D/DRC Case

1447 Hampton Street

DESIGN/DEVELOPMENT REVIEW COMMISSION
DESIGN REVIEW DISTRICT
EVALUATION SHEET
Case # 1

NATURE OF REQUEST: Request for Certificates of Design Approval for new construction of YMCA fitness facility

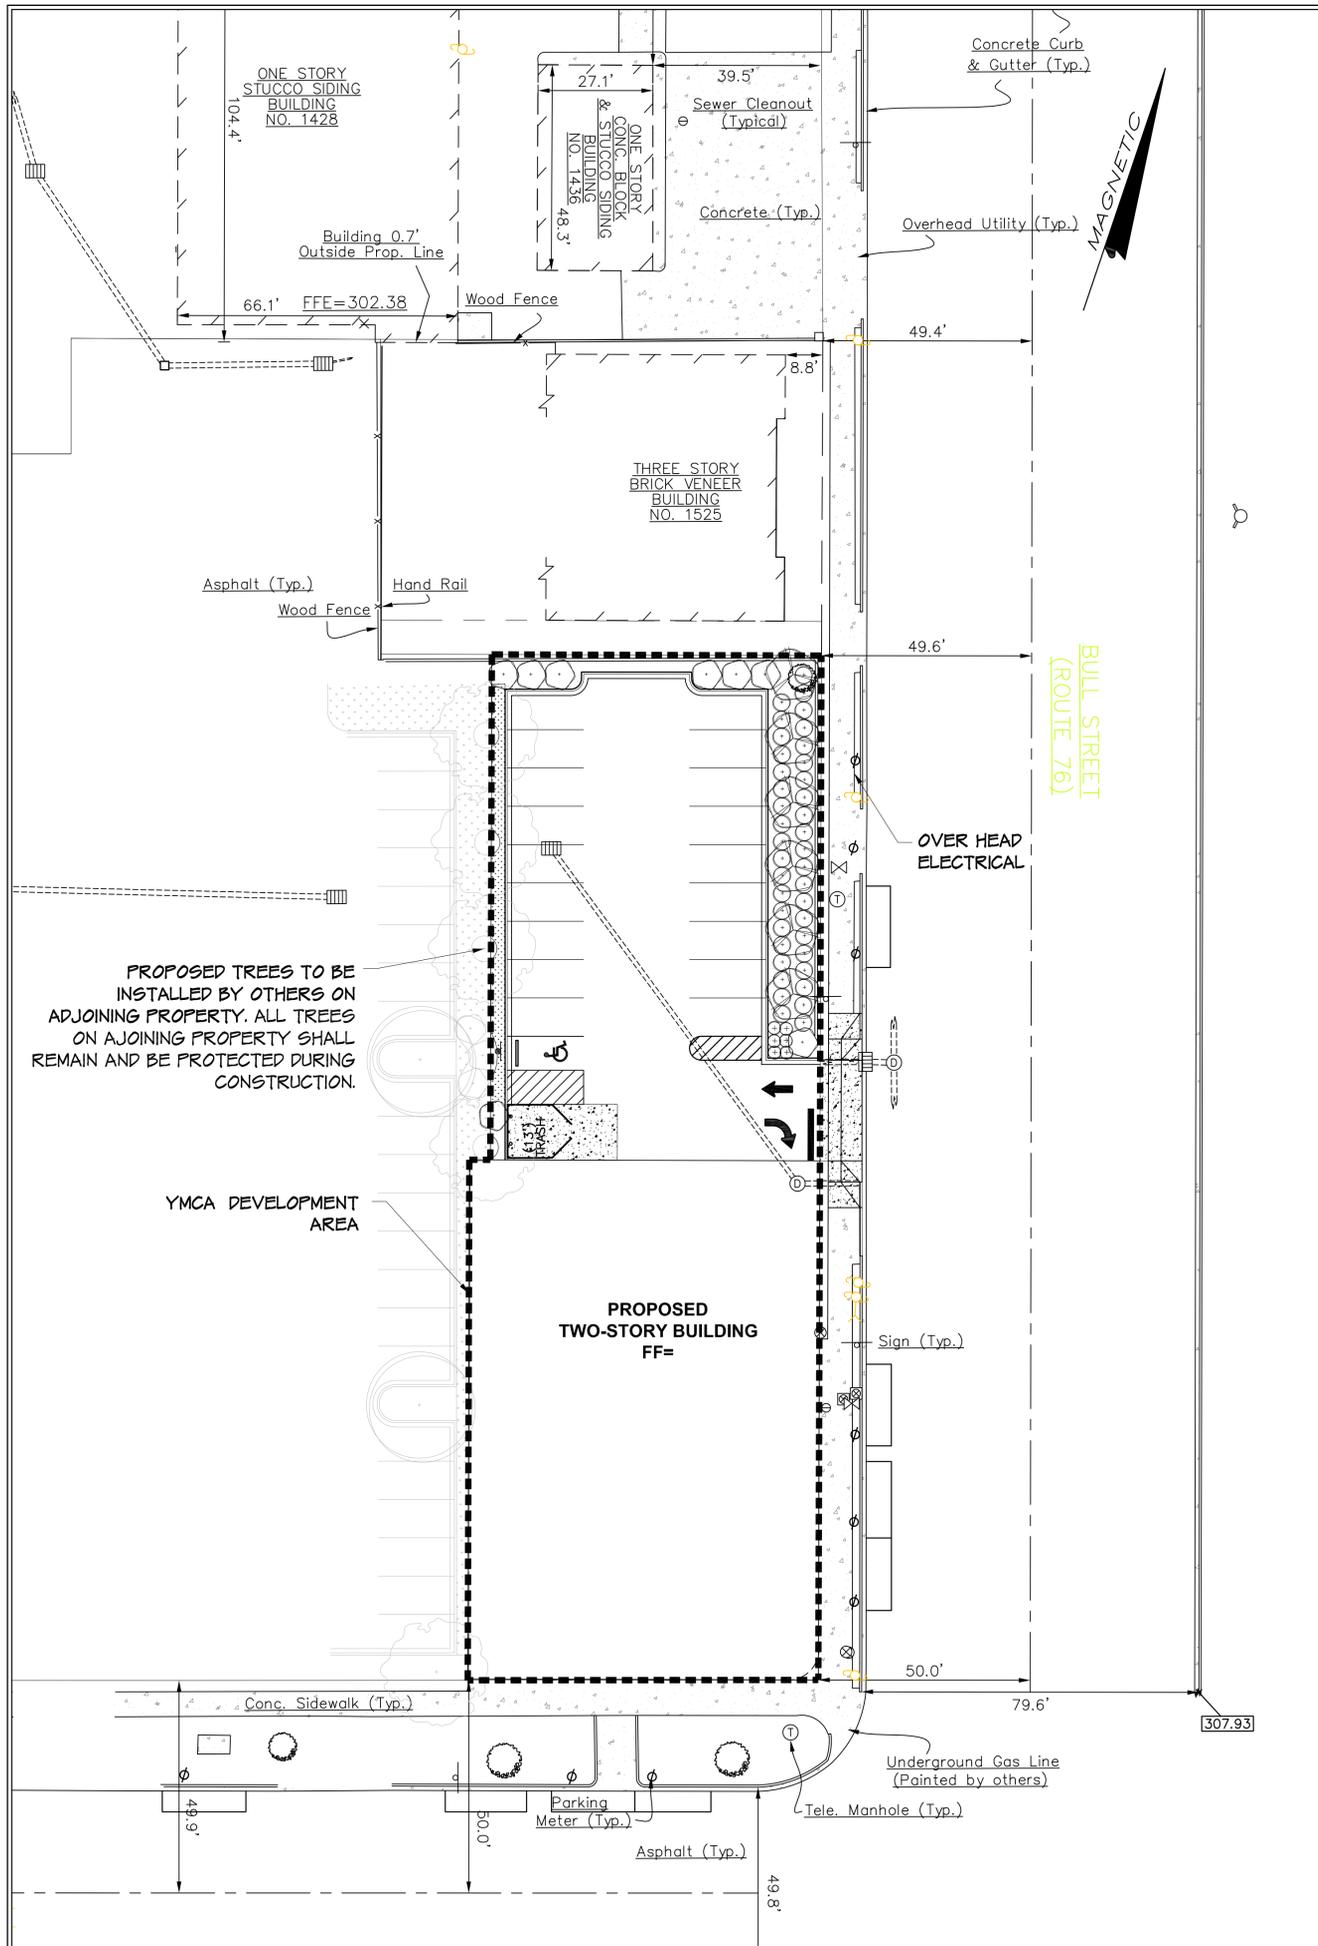
The parking lot is located to the north of the building, and is being evaluated per the City's Landscape Ordinance; it is properly screened with a continuous evergreen hedge and small trees (shade trees are not feasible due to the overhead power lines).

Sheet Title
 EXTERIOR ELEVATIONS

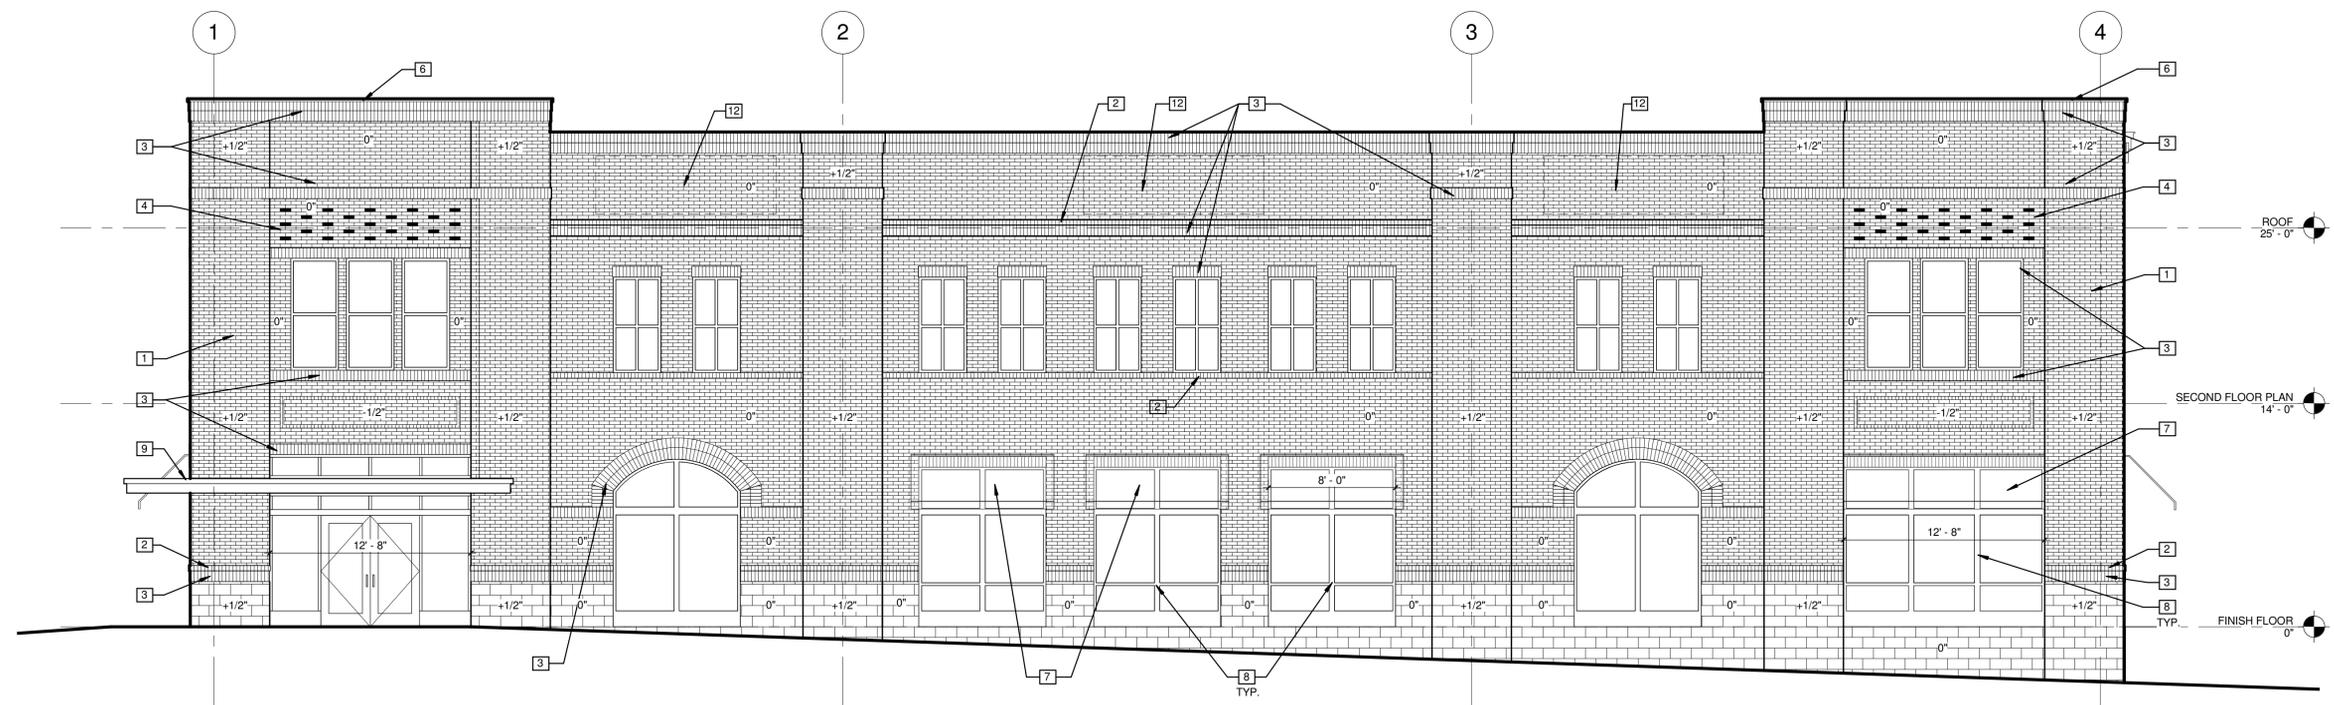
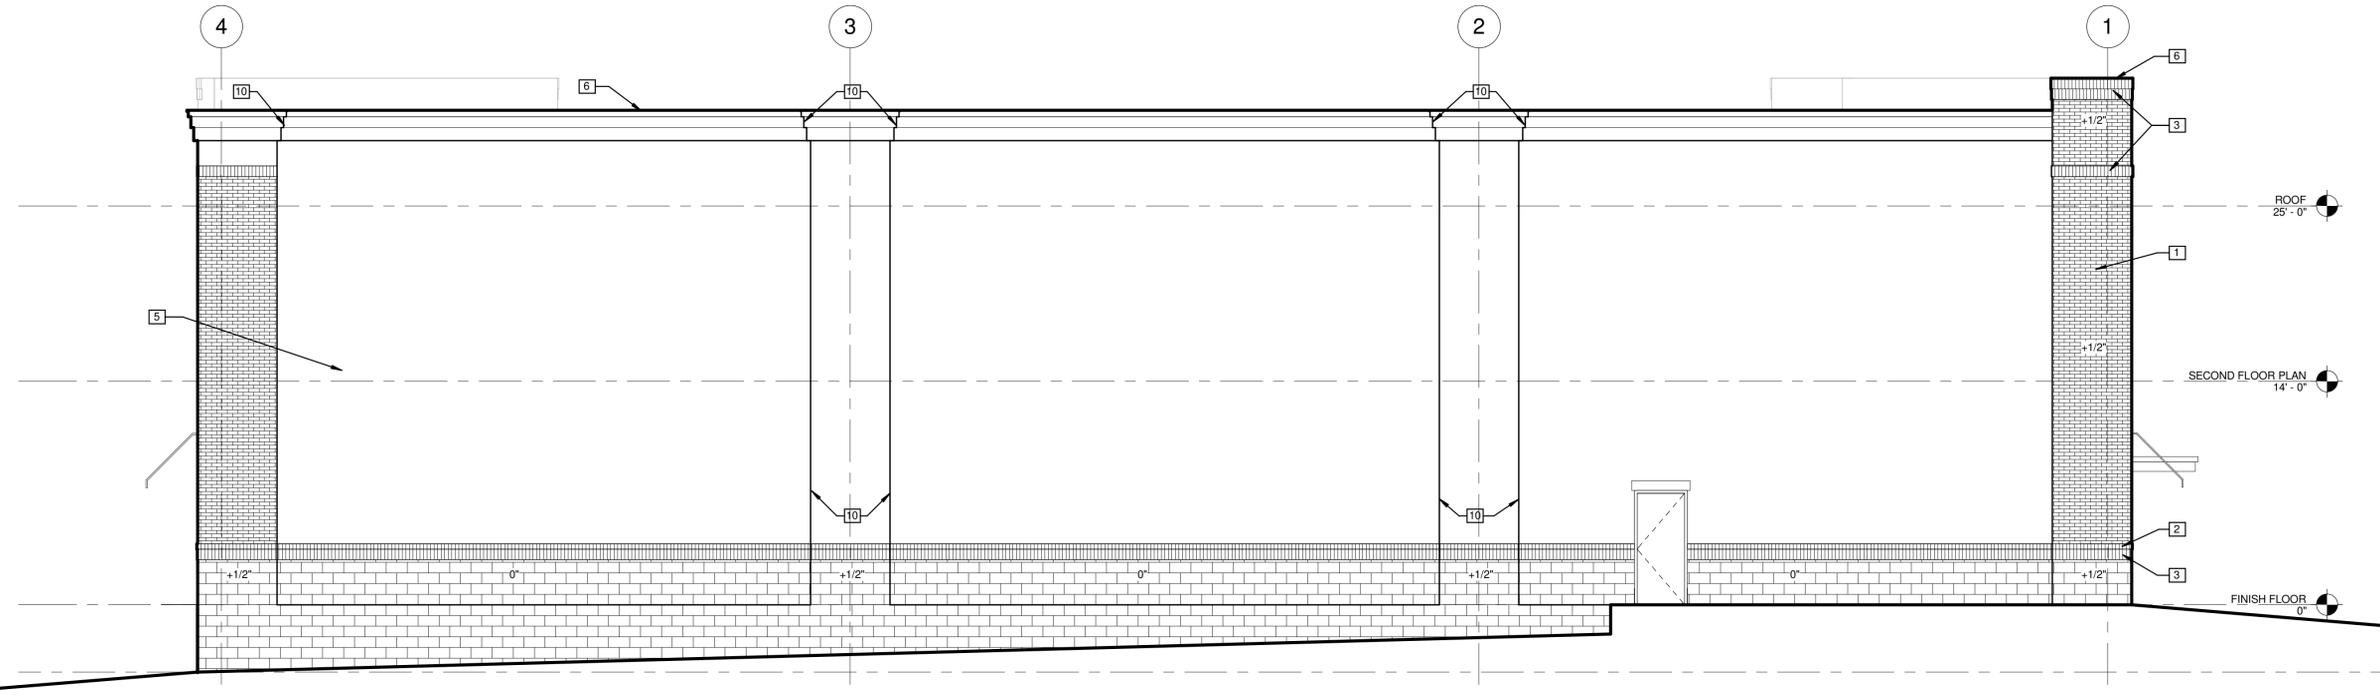
Overall the building's street-facing elevations are compatible with the surrounding context. The architecture draws material cues from the brick apartment building north on Bull Street, and from the Federal Land Bank building on Hampton. However, staff has expressed concern over the north and west facades being of a different material (stucco). Having a different material on the side or rear façades is not consistent with the traditional design of the building, or with the traditional use of materials.

The proportion of openings is conceptually on the right track; however they are smaller than needed to meet the intent of the guidelines. While staff interprets the percentages as a guide, the current openings could easily be enlarged to get closer to the recommended percentages without significant changes to the building design or the architectural detailing. The current ratio (of opening per wall surface for lower and upper) on Hampton Street is 46/26 respectively; Bull Street is 46/23. The renderings appear to have slightly larger windows than the hard-line elevations.

The building elevations have been through several iterations regarding material placement. While the current configuration is greatly improved from the initial design, which had a combination of brick and stucco on the street-facing facades, staff is still concerned about the north and west elevations. While not street-facing, they are very visible from both rights-of-way. The drastic change in material from brick to stucco is inconsistent with the traditional style of the building.

As well, the number of wall materials should be kept to two. The architect did submit a version of the design that maintained the stucco and cut the cast stone. Staff recommended keeping the cast stone, as it adds visual interest to the brick façade. However, with or without the stone, the stucco appears incongruous with the rest of the building.

- The upper story windows be increased in size as much as possible to get closer to the design guideline's recommended percentages
- Window sections and details be submitted to verify a minimum 3" depth and clear glass
- The north and west façades be continuous brick cladding to match the main building's materials; or a combination of stucco and brick if a mural will cover the stucco
- Signage must be reviewed separately and will require an independent CDA
- All details and changes shall be submitted to staff for review and approval
